# CARRIAGE MEADOWS SOUTH FILING NO.2

## A PLANNED UNIT DEVELOPMENT & PRELIMINARY PLAN FOR CARRIAGE MEADOWS SOUTH AT LORSON RANCH FILING 2

PCD FILE NO.: PUDSP-19-5

PUD COVER SHEET & DETAILS P1 OF 10

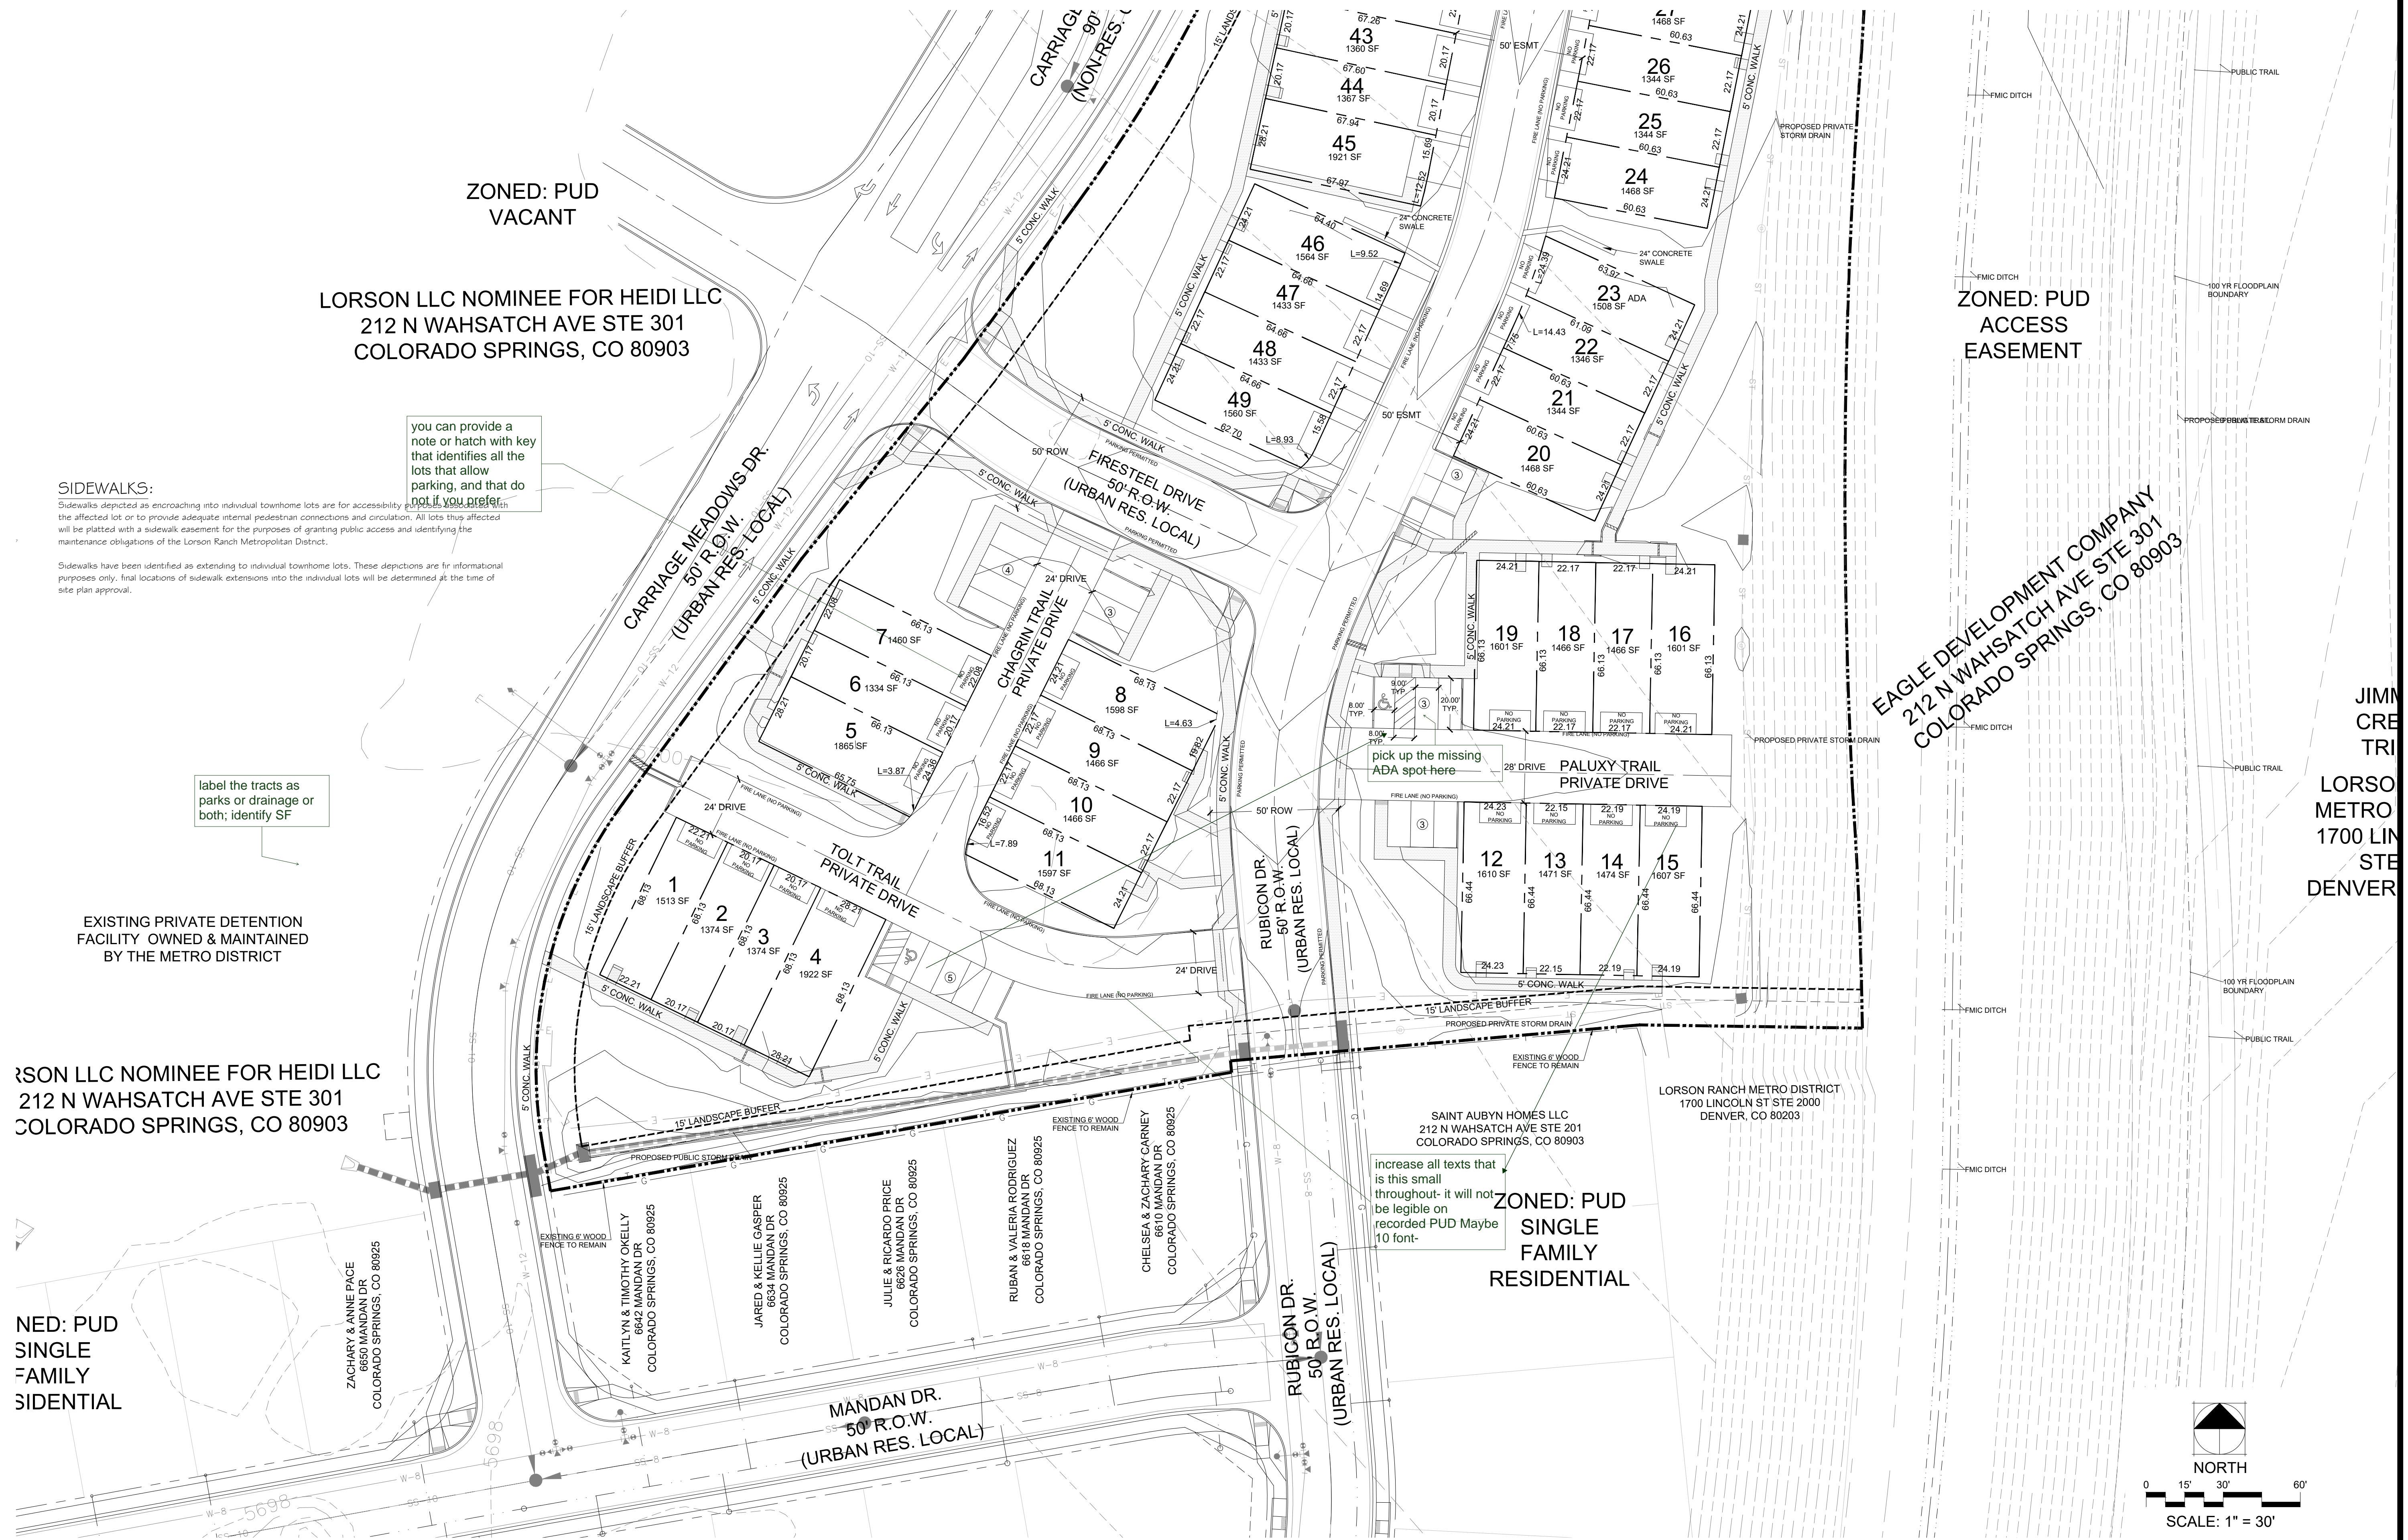
you can provide a note or hatch with key that identifies all the lots that allow parking, and that do not if you prefer.

label the tracts as parks or drainage or both; identify SF

PUD  
SITE PLAN  
P5 OF 10

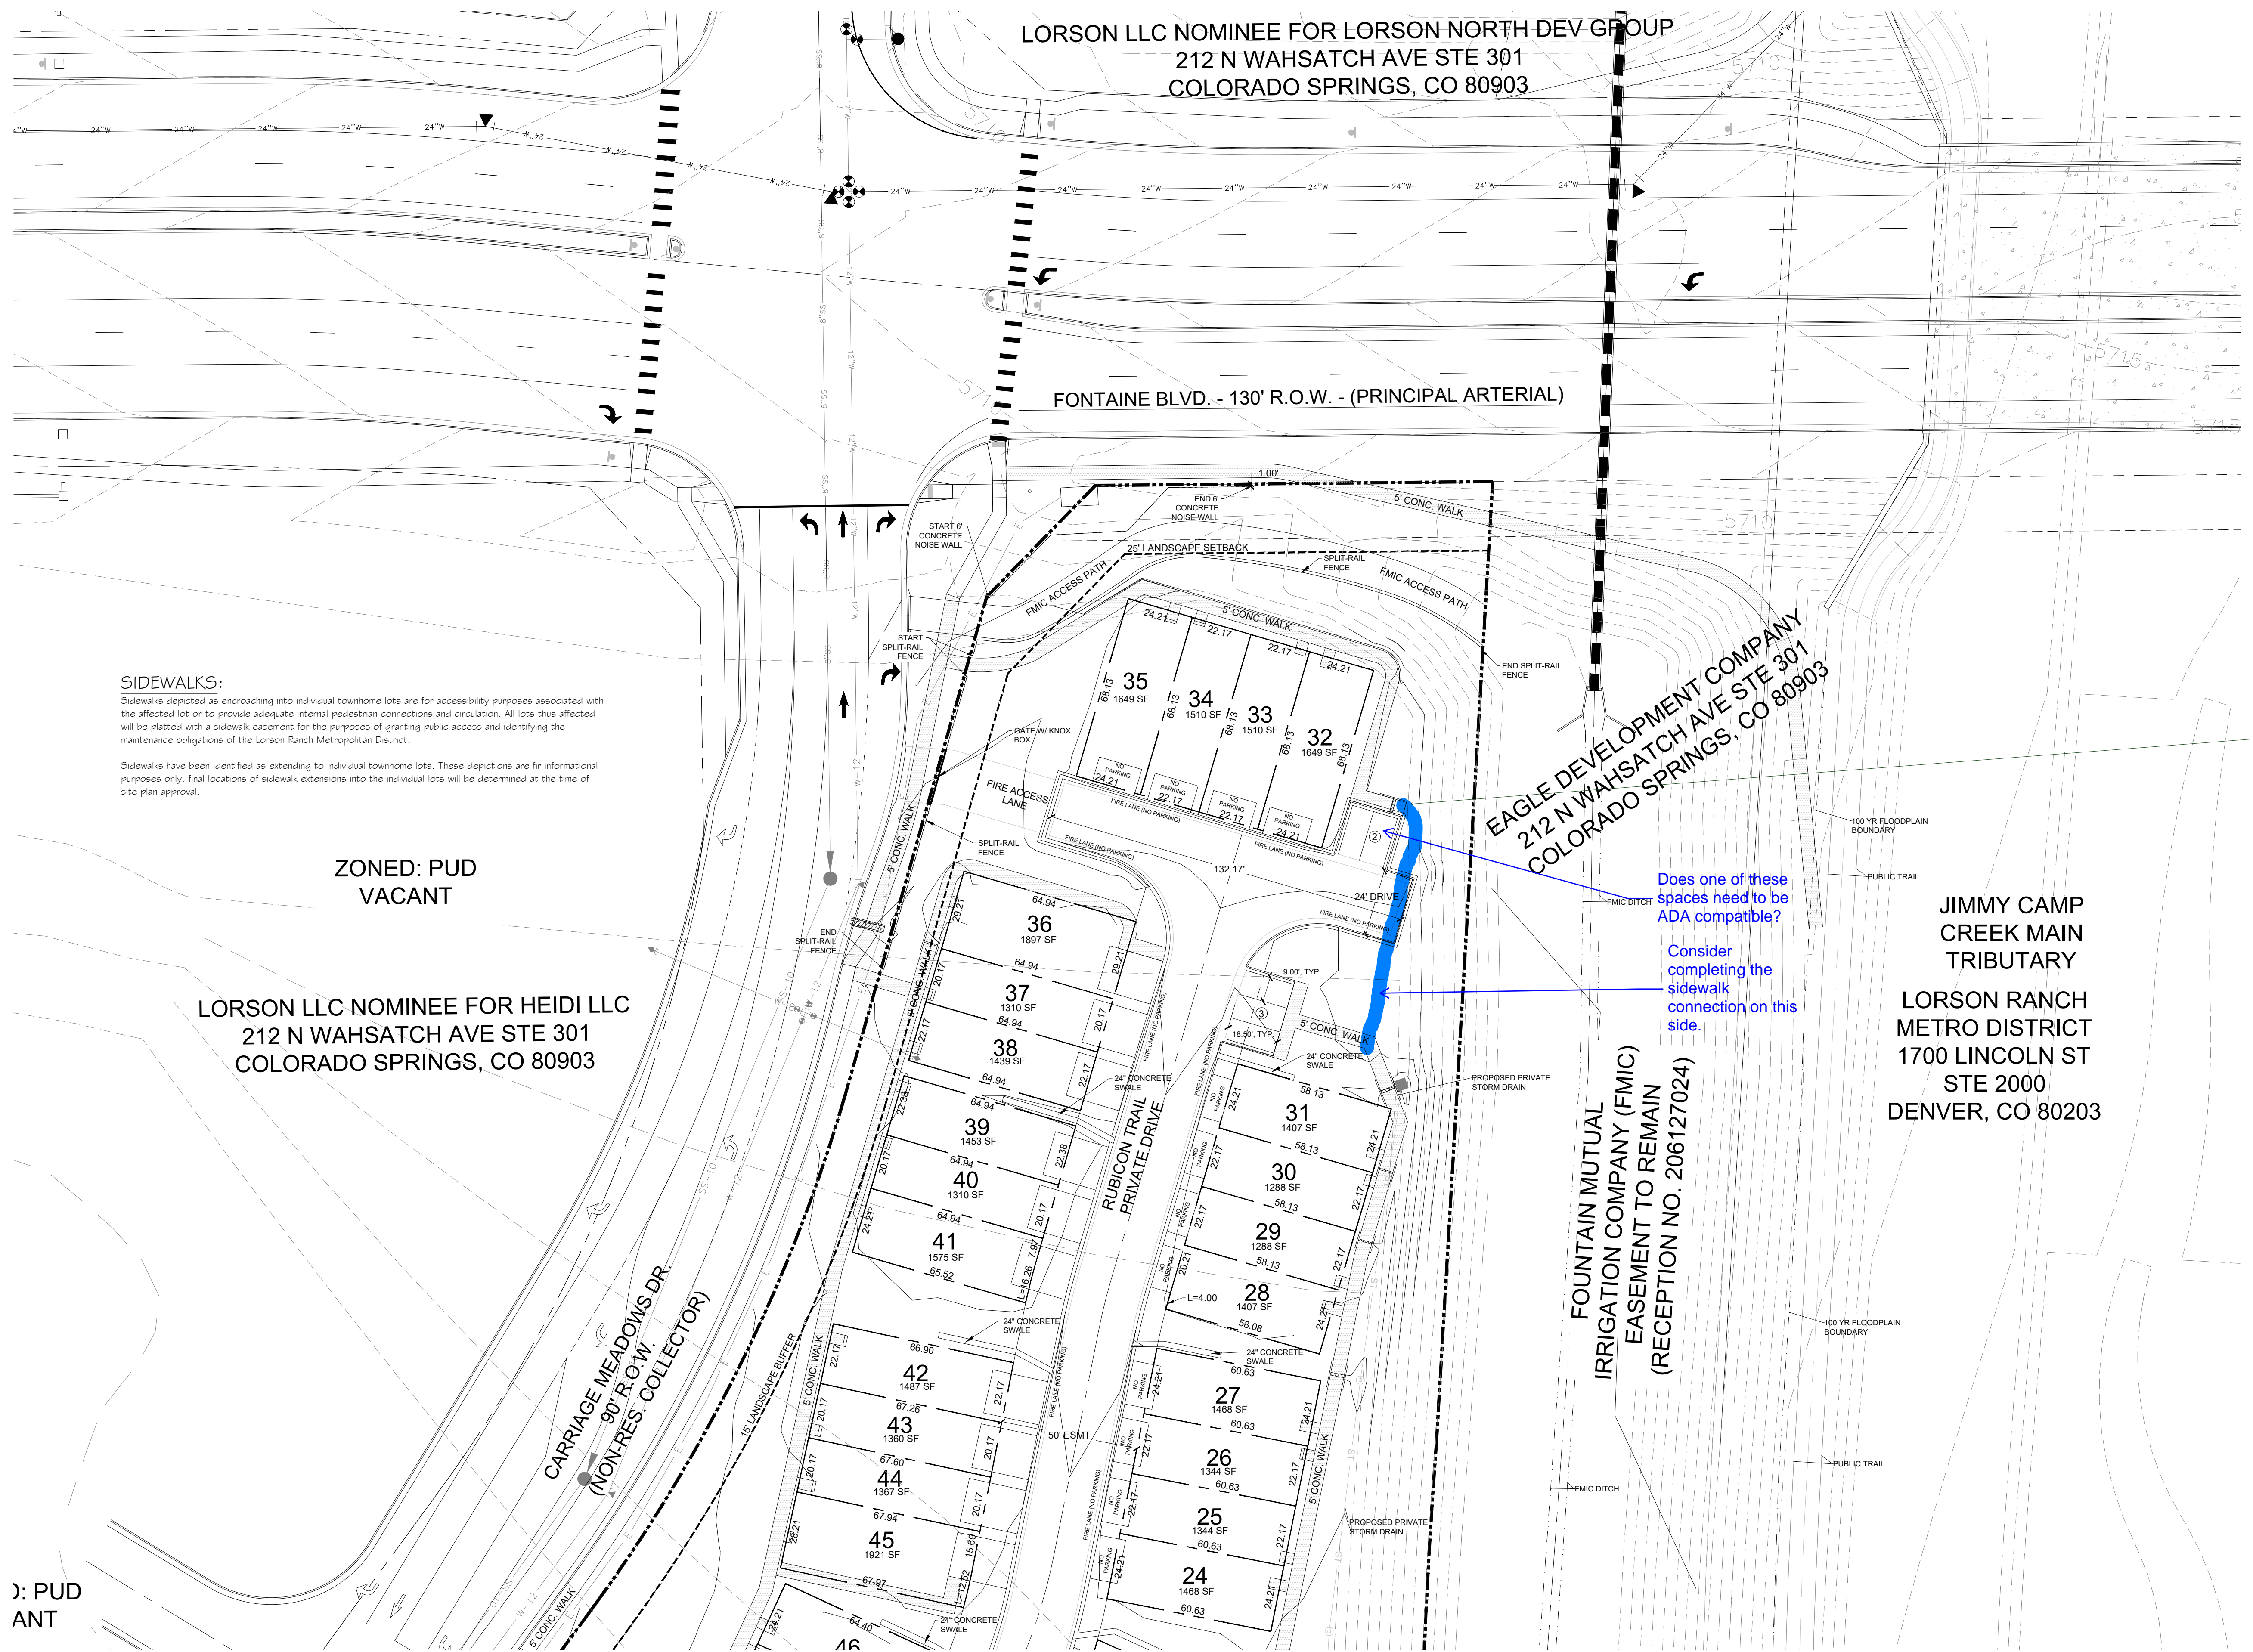
Connect internal  
development to  
amenities in the  
overall community bu  
sidewalk please

which open area is to  
be tot lot or play  
ground? Please  
identify and show  
ADA access.

Does one of these  
spaces need to be  
ADA compatible?

Consider  
completing the  
sidewalk  
connection on this  
side.
